V2500-A5/D5 SERIES PROPULSION SYSTEMS SERVICE BULLETIN

This document transmits Revision 4 to Service Bulletin V2500-72-0534 and Revision 4 to the Supplement

V2500-ENG-72-0534

ENGINE – PROVIDE NEW SECOND STAGE TURBINE AIR SEAL**1. Planning Information****A. Effectivity****(1) Airbus A319**

pw0b519183B

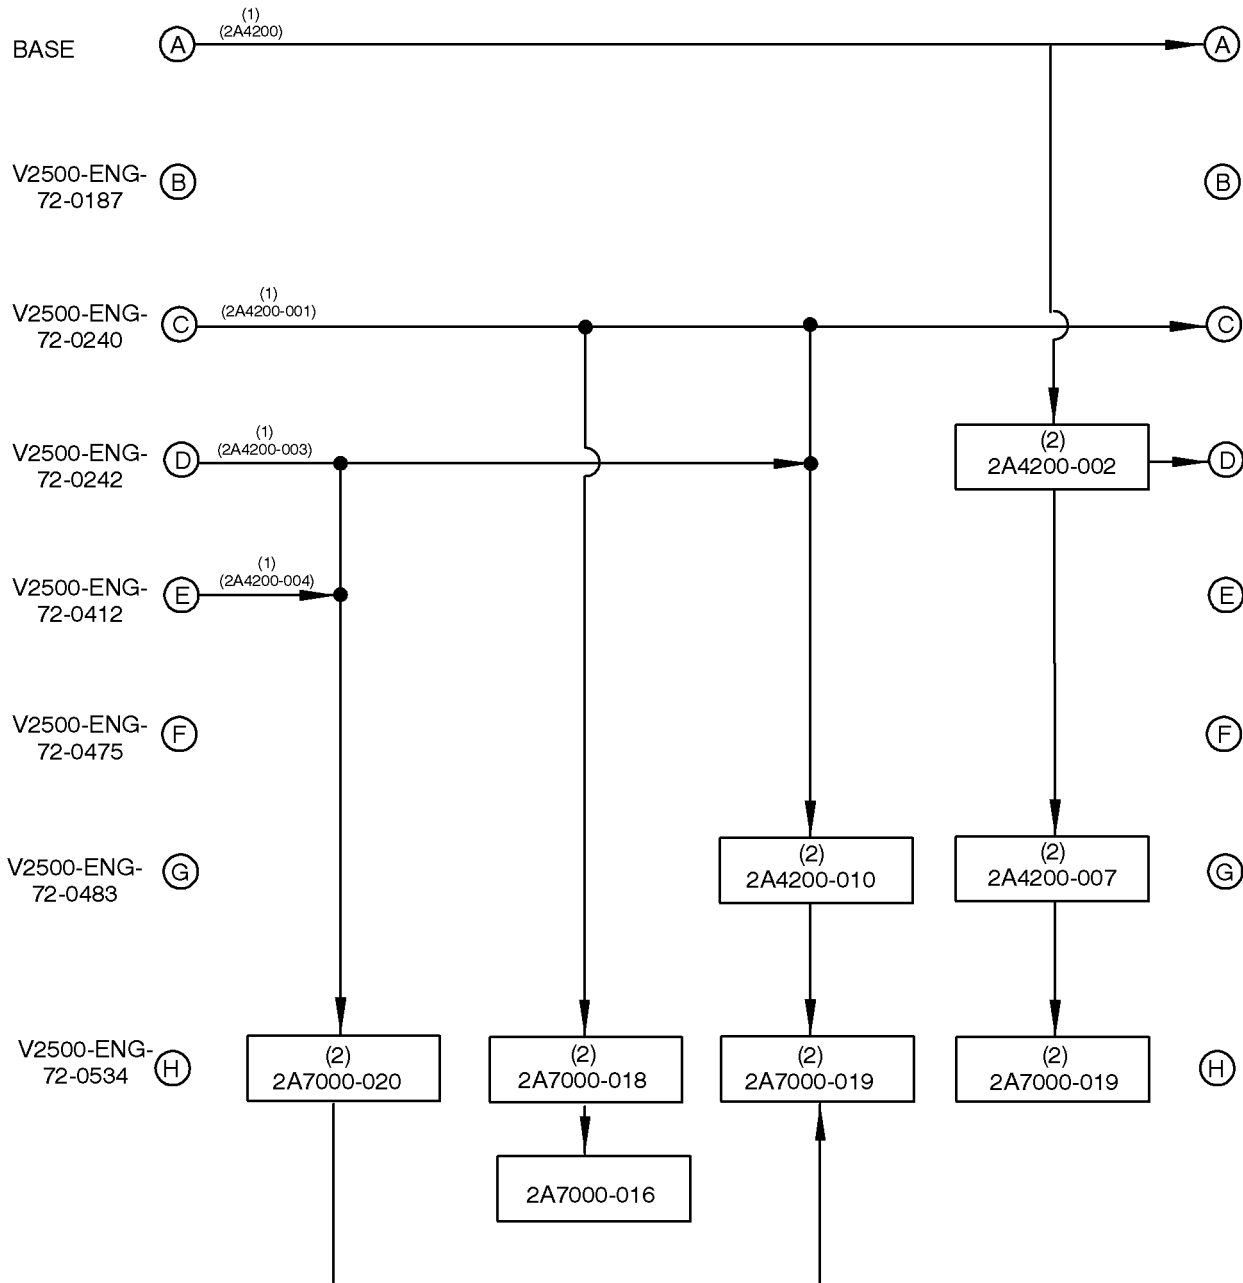
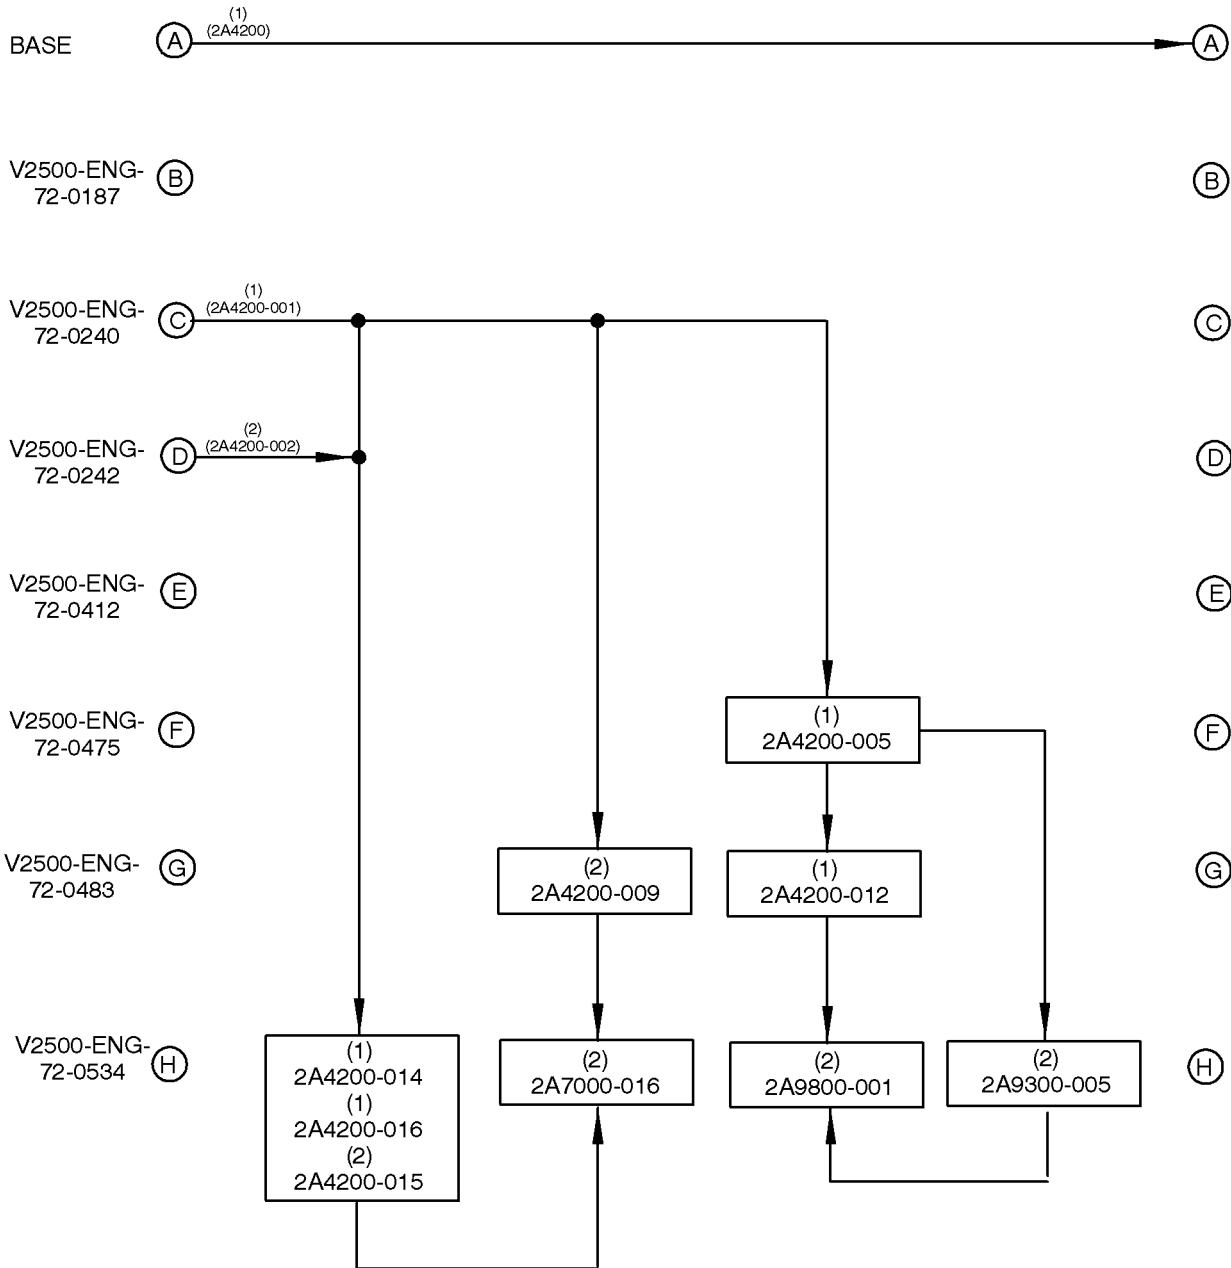
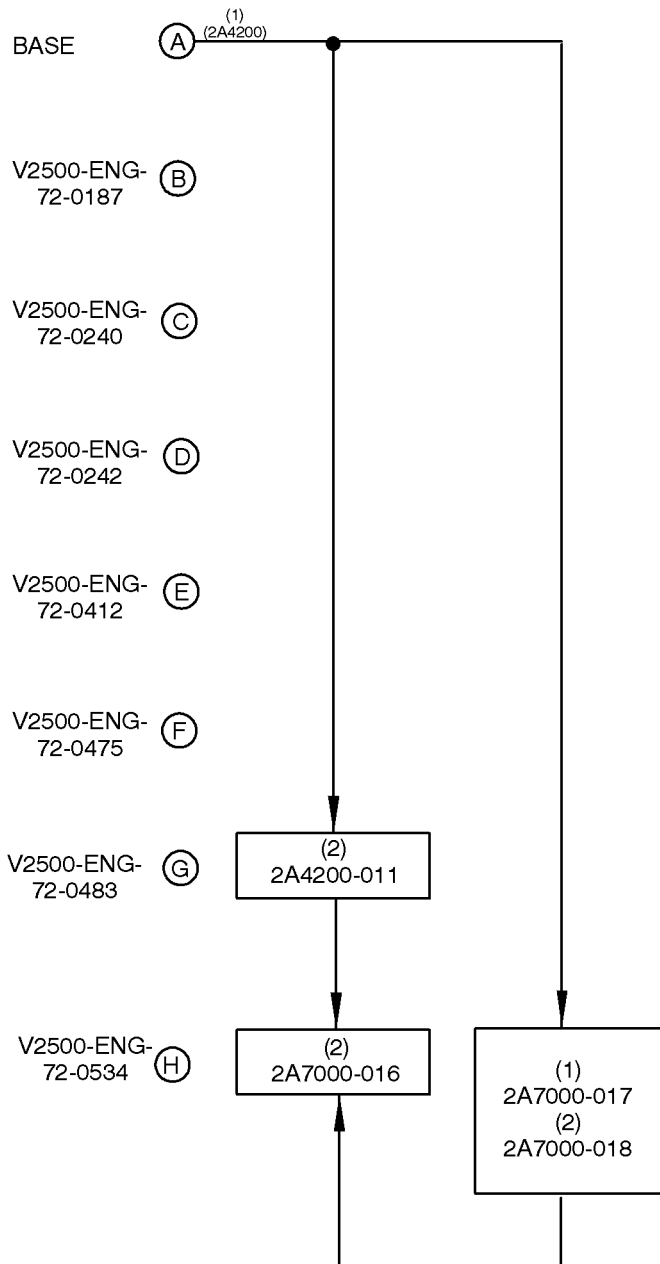
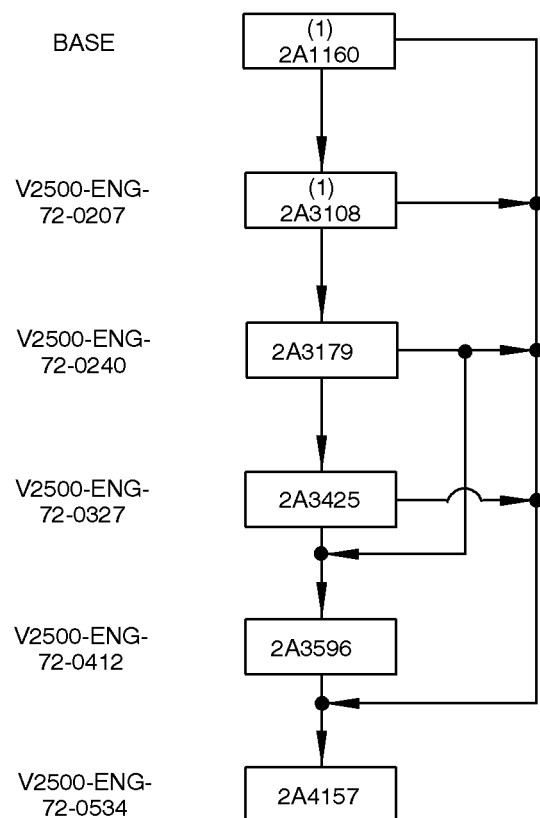
Remove	Incorporate	Reason for change
All pages of the Service Bulletin	Pages 1 to 29 of the Service Bulletin	To provide correct part numbers, which had been transposed, in the Interchangeability of Parts section.
All pages of the Supplement	Page 1 of the Supplement	None.

R The new seal, PN 2A4157 is only one-way interchangeable with the current seal,
R PN 2A3596. The new seal may be fitted in lieu of the old seal but not vice-versa.
